## A/C Condenser Fan Relay

<b>Bulletin Type:</b>	TSB	<b>Publication Date:</b>	December 2025
<b>Bulletin #(s):</b>	25-025	<b>Make(s):</b>	Entegra Coach
<b>Job Code(s):</b>	9803643	<b>Model(s):</b>	Aspire, Anthem, Cornerstone, Cornerstone Reserve
<b>Flat Rate(s):</b>	9803643 .50 HR A/C Condenser Fan Relay Repair	<b>Model Year(s):</b>	2023-2026

## A/C CONDENSER FAN RELAY REPAIR INSTRUCTIONS

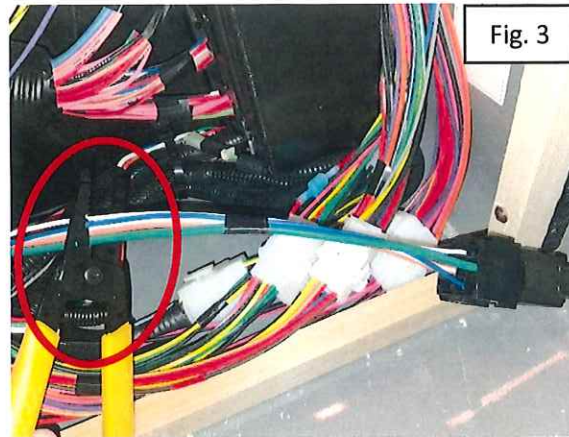
2. Locate the 40A relay for the condenser fans. (Figure 2)

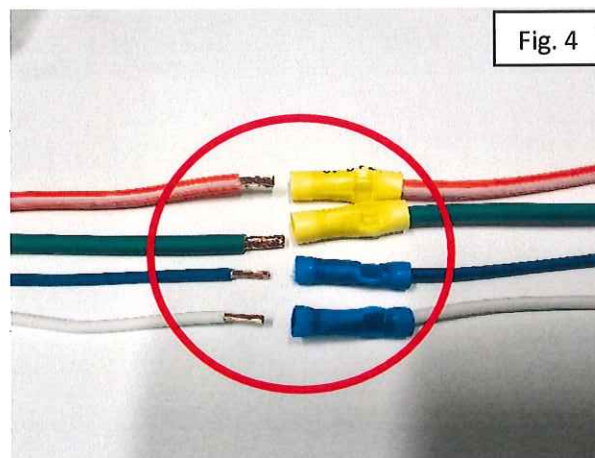
3. Remove the relay from the backer in the compartment with a screw gun and square head bit. Using wire strippers, cut the wires from the relay.
  - a. **Note: You will want to cut roughly 8-10" back from the relay.** (Figure 3)

4. Use the wire strippers to strip the wires still in the coach.
  - a. **Note: You will only want to strip enough wire to use in the supplied butt connectors.** (Figure 4 – left hand side)

5. Use the butt connectors on the 80A relay assembly to wire the relay to the coach.
  - a. **Note: You will want to connect the wires matching color to color, (blue to blue, green to green, white to white and orange/white to orange/white)** (Figure 4 – right hand side)
6. Secure the new 80A relay assembly to the board in the same location the 40A relay was removed from.
